IEEE802.3da standard review

10/15/2025

Figure 189–9—Top level MPD state diagram continued, part b

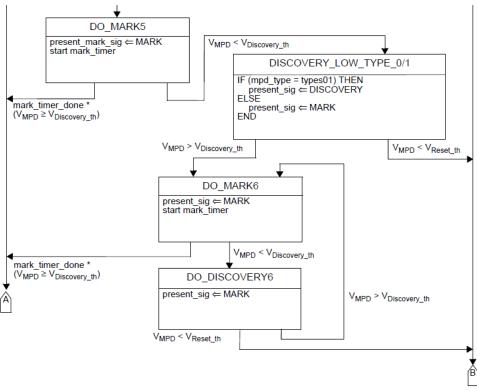
Clause/Table	Issue	Suggested remedy	Notes
		Make note to the table 189-8:	
	Flow chart on Fig 189-9 has 6 events of discovery however in a table 189-8 there are 5 events of discovery.	Option 1: Discovery Event 6 does not add additional discovery	
Table 189-8		information and could be used for future application.	
		Option 2 (from Michael Paul presentation MPoE Discovery	
		Extensibility): Bit 6 = 0 signals that the information was for T1M	
		multidrop	٥

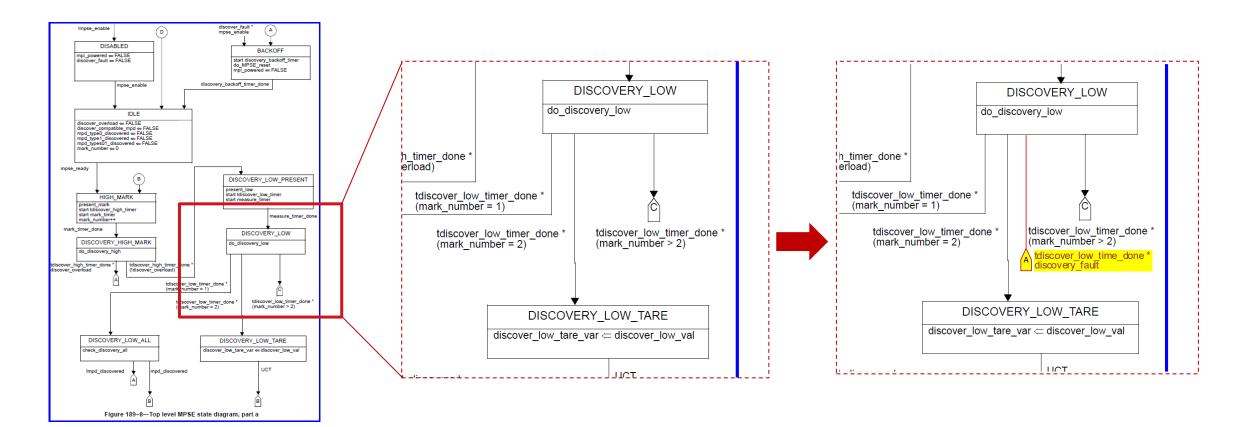
Clause/Table	Issue	Suggested remedy	Notes
Figure 189–8	Overload during DISCOVERY_LOW is not covered in the state- machine	Add an exit to "A" (backoff) from "DISCOVERY_LOW" if "discovery_fault" is received from "do_discovery_low"
